Informal document **GRSP-52-14**
(52nd GRSP, 11 – 14 Decemer 2012,
agenda item 11)

Regulation No. 16 (Safety-belts)

Proposal for Supplement 4 to the 06 series of amendments to Regulation 16 (safety belts)

Paragraph 8.1.8., amend to read:

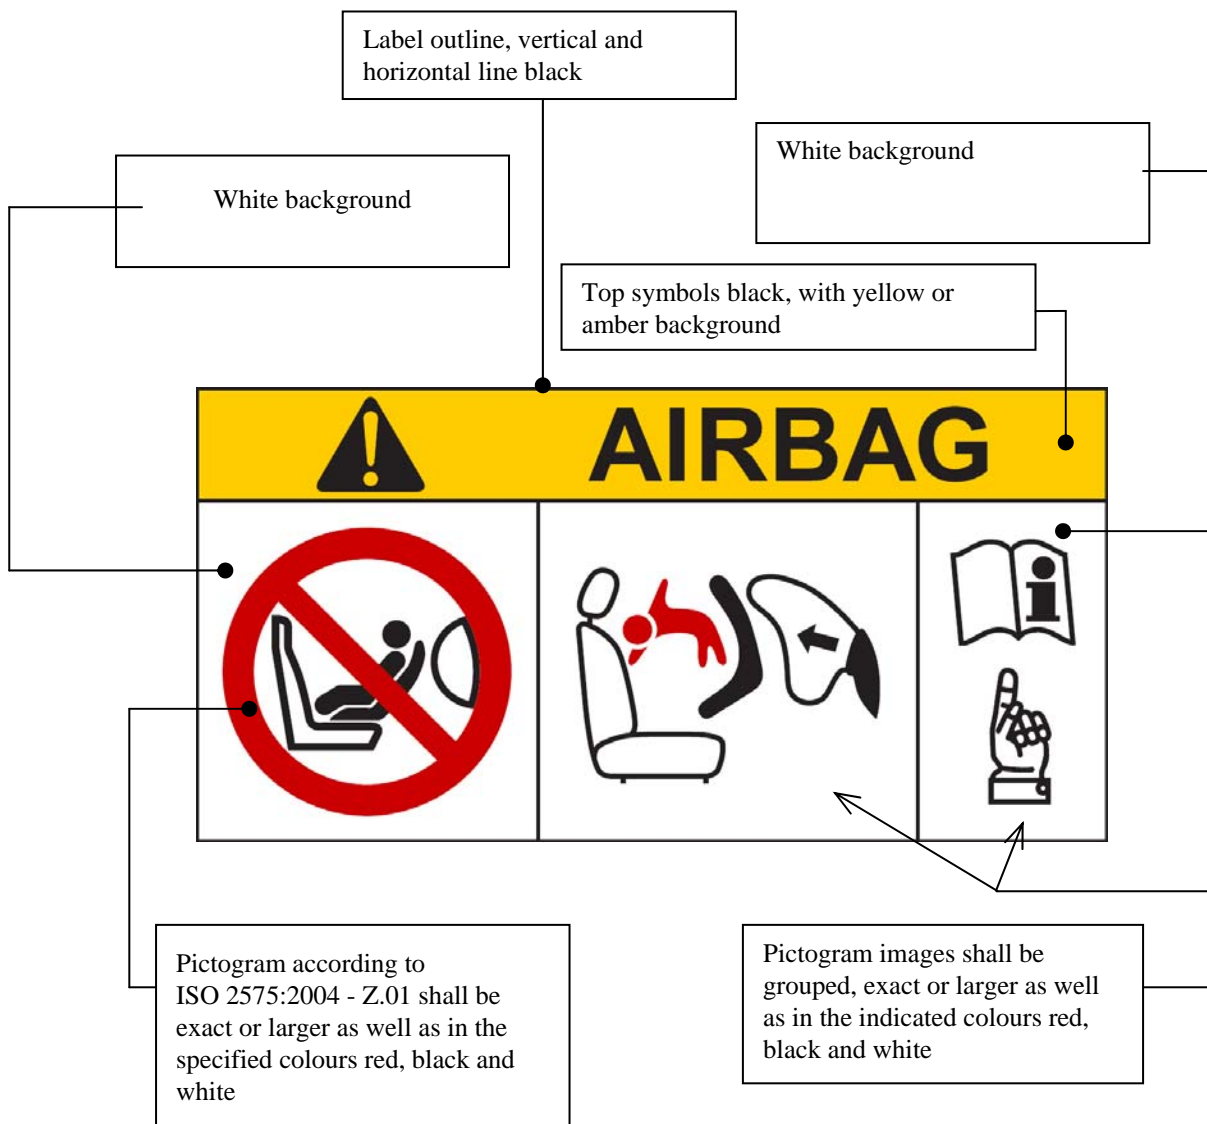
"8.1.8. ~~With the exception of the case covered by paragraph 8.1.9, Every~~ passenger seating position which is fitted with ~~an~~ **a frontal protection** airbag shall be provided with a warning against the use of a rearward-facing child restraint in that seating position. ~~The warning label, in the form of a pictogram which may include explanatory text, shall be durably affixed and located such that it is easily visible in front of a person about to install a rearward-facing child restraint on the seat in question. An example of a possible design of a pictogram is shown in Figure 1. A permanent reference should be visible at all times, in case the warning is not visible when the door is closed. As a minimum, this information shall consist of a label containing clear warning pictograms as indicated below:~~

The overall dimensions shall be at least 120 x 60 mm or the equivalent area.

The label shown above may be adapted in such a way that the layout differs from the example above; however, the content shall meet the above prescriptions."
